RE: Skagway Ore Peninsula Redevelopment Descoping Pricing

Please find attached Pacific Pile & Marine's (PPM) proposal for the Skagway Ore Peninsula Redevelopment De-Scoping Pricing based on drawings received 07/05/2023 and discussions thereafter.

ORE PENINSULA REDEVELOPMENT
SKAGWAY, ALASKA

Concept De-Scoping Plan - 07/05/2023

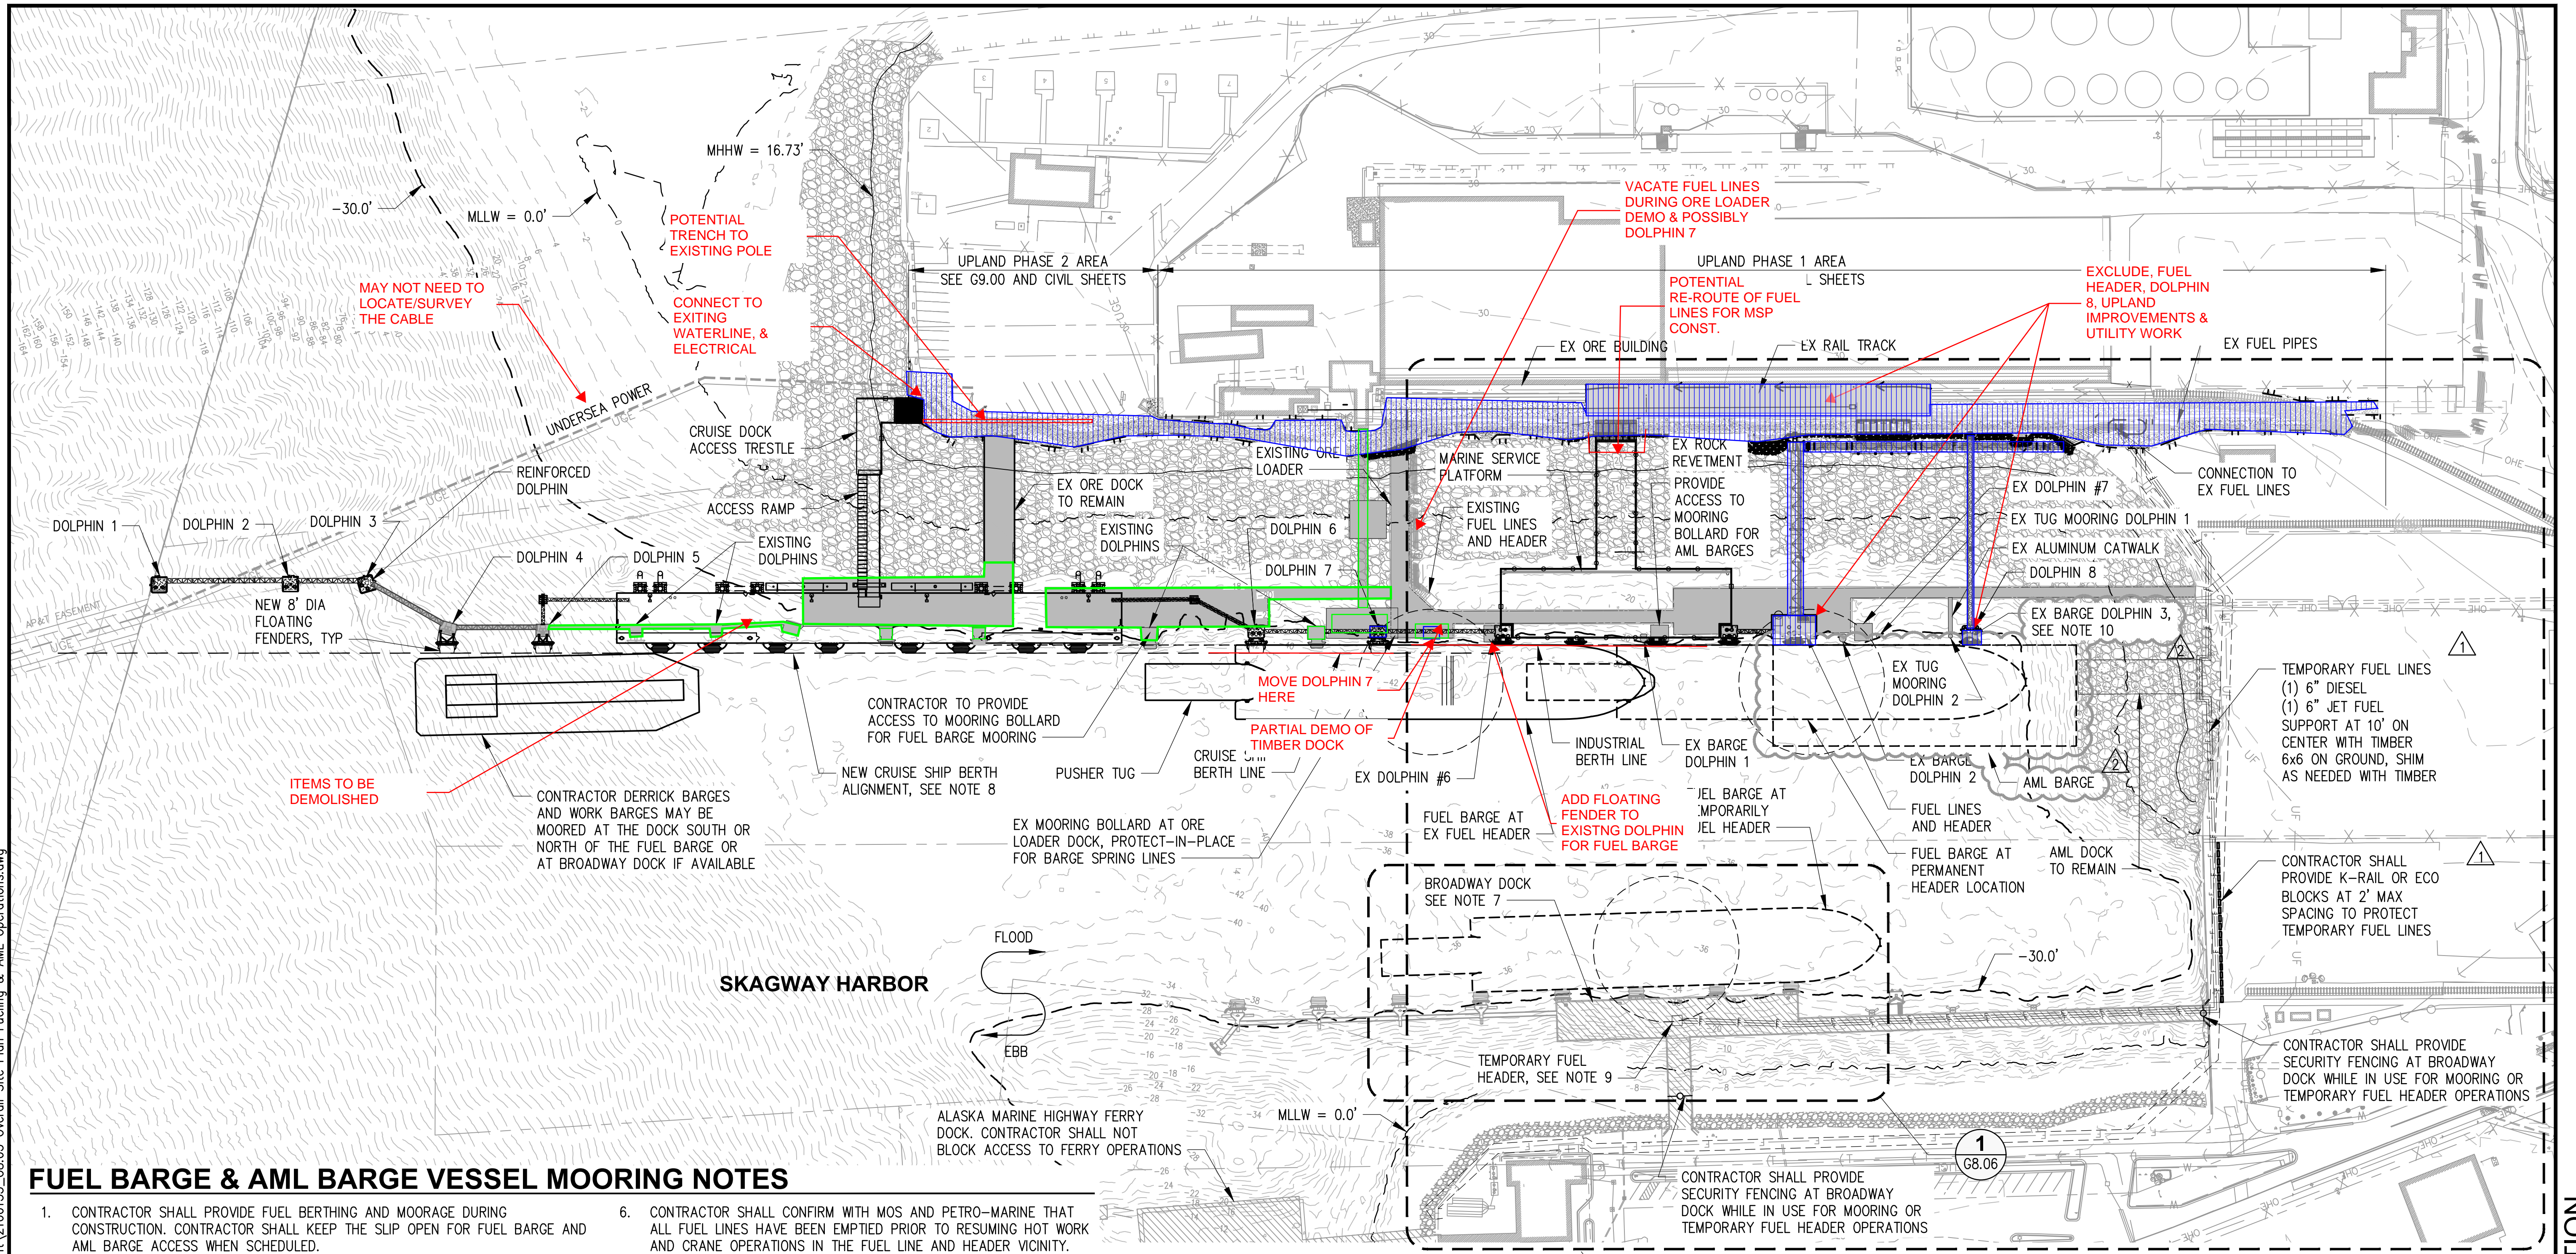
PPM has amended demolition pricing based on the descoping drawing provided by KPFF on 07/05/2023 and has provided an additional marked up drawing to clarify the scope.

- *Existing Dolphin 5*
 - PPM will demolish and dispose Existing Dolphin #4 including piles, fender, and cap per drawing D1.04.
 - Existing Dolphin 5 is mis-numbered on drawing G8.05 and the Concept De-Scoping Plan – 07/05/2023 drawing provided by KPFF. This dolphin will be removed and disposed of in Season 2 and will be considered as part of the MSP Additive item.

DRAWN: JH	PROJECT NO.: 2100135
DESIGN: ED	SCALE: AS SHOWN
CHECKED: RR	DATE: 05/04/2023
DRAWING NO.	G7.00
SHEET NO.	8 OF 374

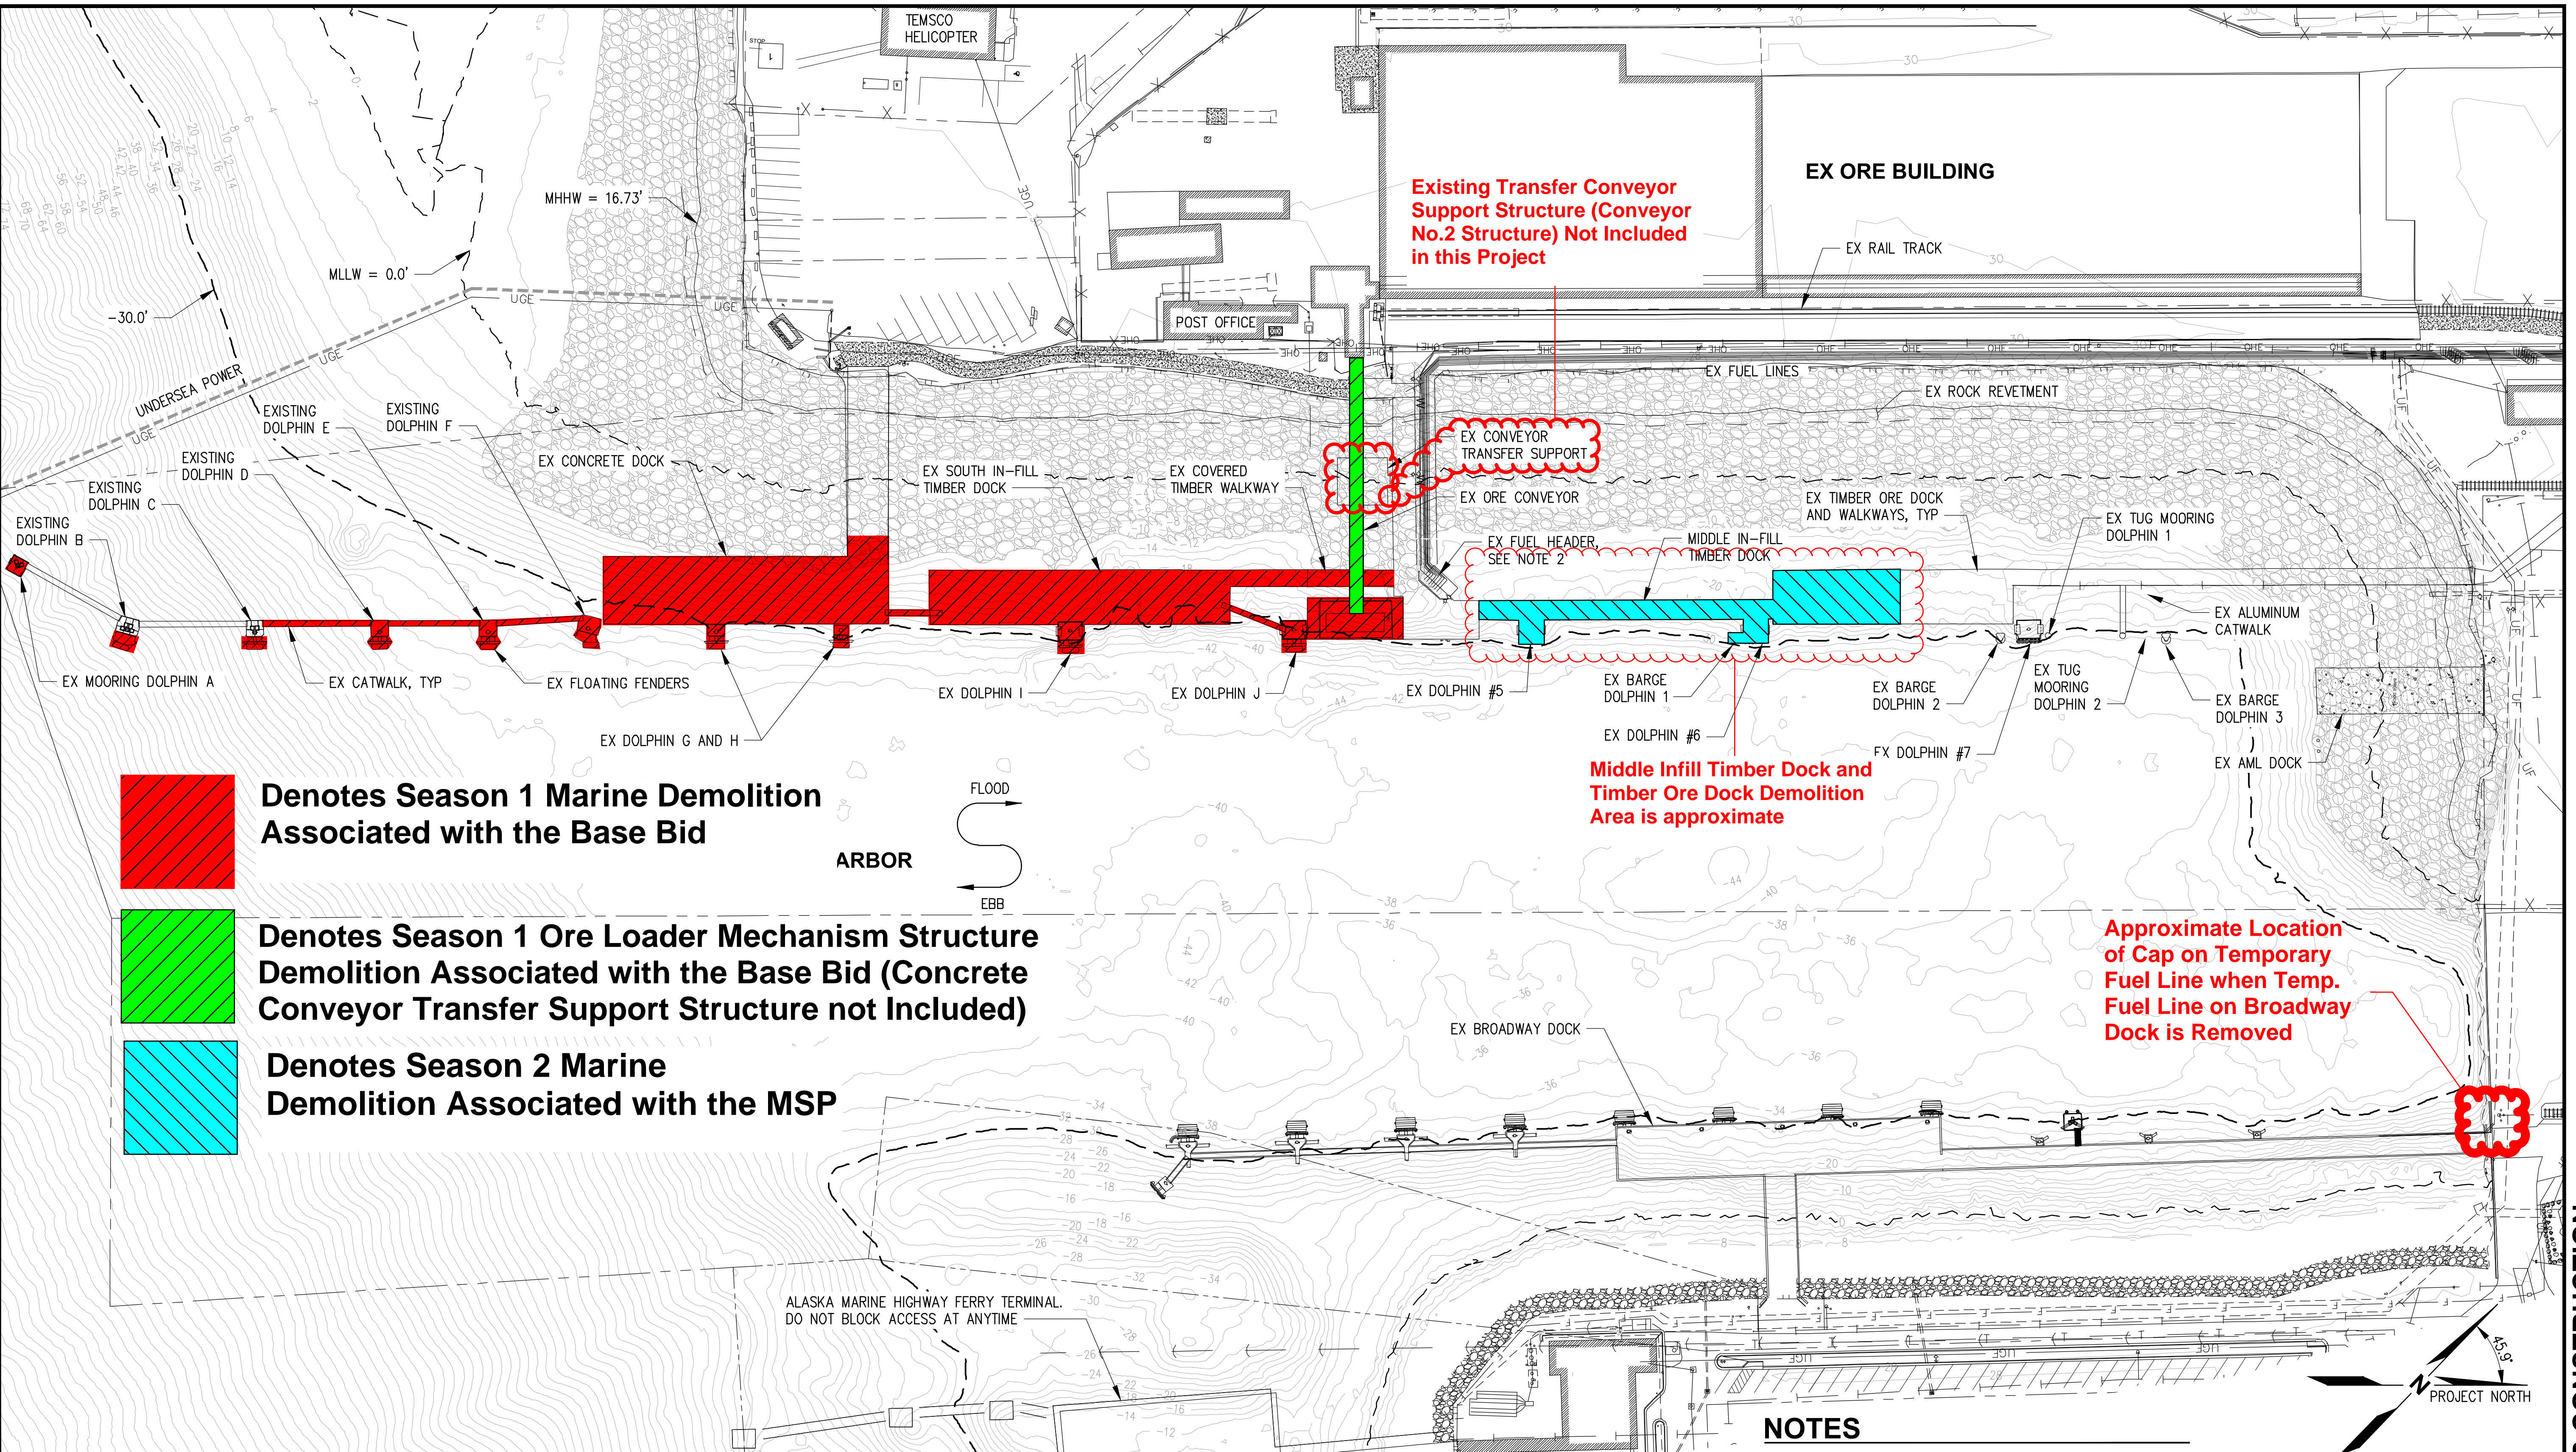
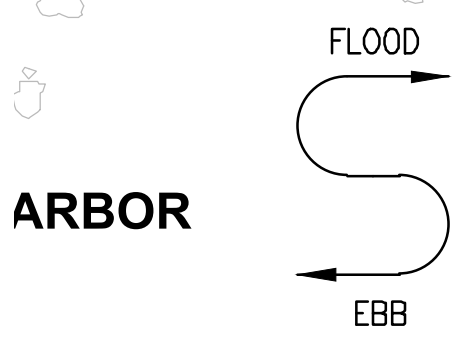
Denotes Season 1 Marine Demolition Associated with the Base Bid

Denotes Season 1 Ore Loader Mechanism Structure Demolition Associated with the Base Bid (Concrete Conveyor Transfer Support Structure not Included)

Denotes Season 2 Marine Demolition Associated with the MSP
